Government of India
Central Electricity Authority
System Planning & Project Appraisal Division
Sewa Bhawan: R.K.Puram
New Delhi-110066

Subject: Special meeting to discuss the issues related to LTOA.

Agenda for the special meeting of the Standing Committee on Power System Planning of Western Region to be held on 18.04.2009

Sub: 28th meeting of the Standing Committee on Power System Planning of WR –
Comments of Chhattisgarh State Power Transmission Company Ltd

PROPOSED CONNECTIVITY AT VINDHYACHAL POOLING

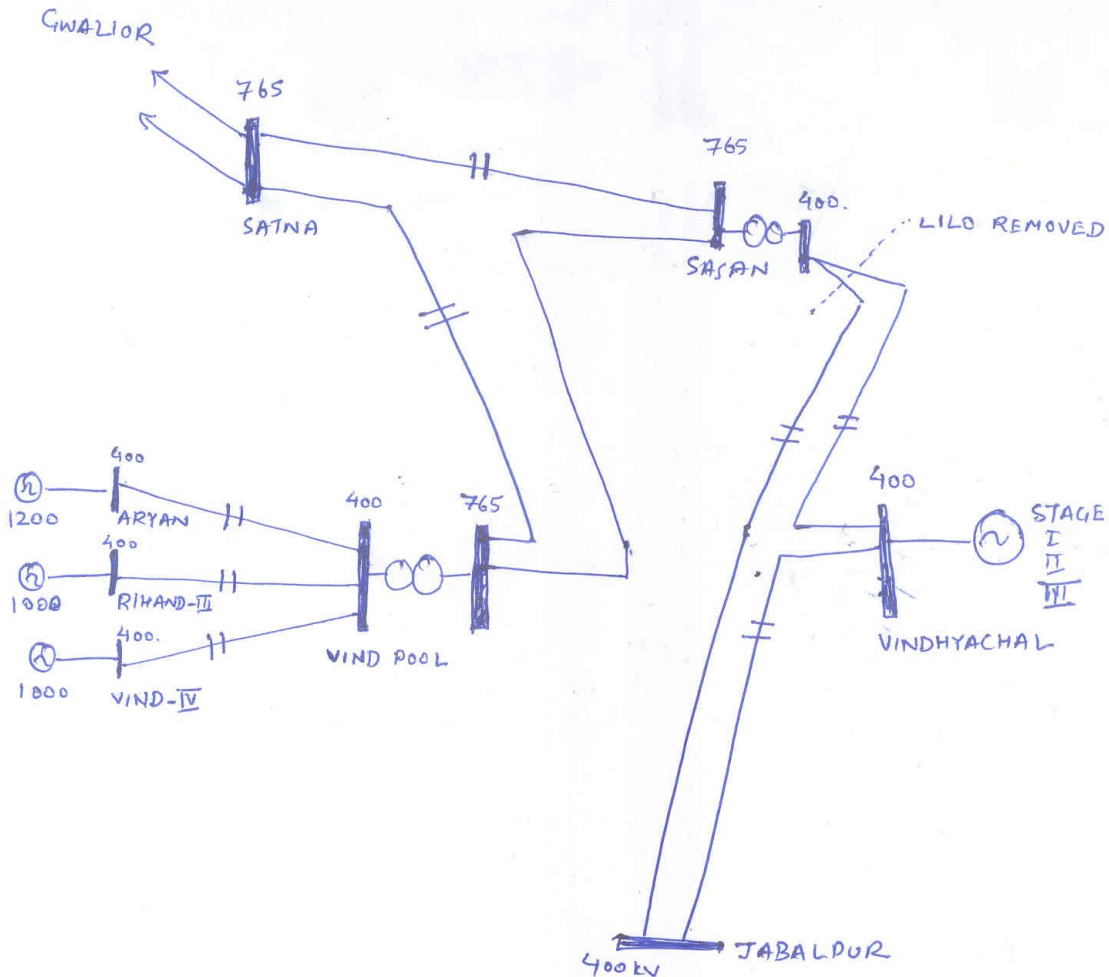
NTPC vide letter dated 15.12.08 had informed that fault level of existing 400kV bus at Vindhyachal station would exceed the permissible limits even without its connection with Vindhyachal-IV due to its interconnection with Sasan Generating station through LILO of Vindhyachal-Jabalpur 400kV D/c line at Sasan approved as a part of Sasan generation project. Accordingly, the matter was examined and it is found that in order to reduce the short ckt MVA at Vindhyachal generating station, LILO of Vindhyachal – Jabalpur 400kV D/c line at Sasan may be disconnected at a later date after establishment of 765/400 kV Vindhyachal Pooling station but before commissioning all units. To keep the connectivity of Sasan and Vindhyachal pooling station, Sasan-Vindhyachal pool 765 kV S/C line could be established as a new transmission line.

It needs to be noted that NTPC has proposed interconnection of both 400 kV and 765 kV Vindhachal pooling point buses with Sasan UMPP 400 kV and 765 kV buses to increase the reliability and redundancy of power evacuation from both the projects.

At Vindhyachal pooling point, Rihand-III (1000 MW), Vindhyachal-IV (1000 MW) and Aryan Coal (1200 MW), are presently proposed to be connected. As the generators would be coming in different time frame, the transmission system connected with Vindhyachal pooling station requires to be phased. The following phasing is suggested:

- (i) When the initial unit at Vindhyachal stage-III and Rihand-III generation are commissioned they could be connected to Vindhyachal Pooling point and the Vindhyachal Pooling-Satna-Gwalior 765 kV link is charged at 400 kV level.

- (ii) In this time frame few units at Sasan would only be commissioned and there would not be any short circuit level problems at Vindhachal 400 kV generating bus due to LILO of Vindhachal- Jabalpur 400 kV D/C at Sasan.
- (iii) When the entire planned generating stations connected to Vindhachal pooling station are commissioned, at that stage the Vindhachal Pooling-Satna-Gwalior link can be charged at 765 kV level along with interconnection of Sasan-Vindhachal 765 kV S/C.
- (iv) After charging at 765 kV level the LILO of Vindhachal – Jabalpur 400 kV D/C line at Sasan could be disconnected with suitable switching arrangements at Sasan 400 kV switchyard to meet its starting power requirements.
